CITY OF TONTITOWN PLANNING OFFICE

Project: Verizon Cell Communication
Tower Conditional Use Permit

AGENDA ITEM PH1 & PC1

CONDITIONAL USE PERMIT REQUEST

Figure 4: Site Plan

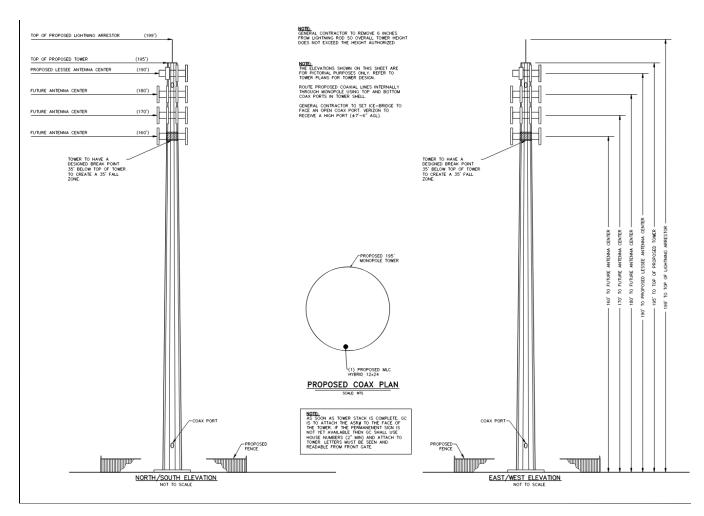
There is one gravel drive to access the site and a turn-around area planned. The drive and turn-around area comply with the City and Fire code. No parking is planned for the site.
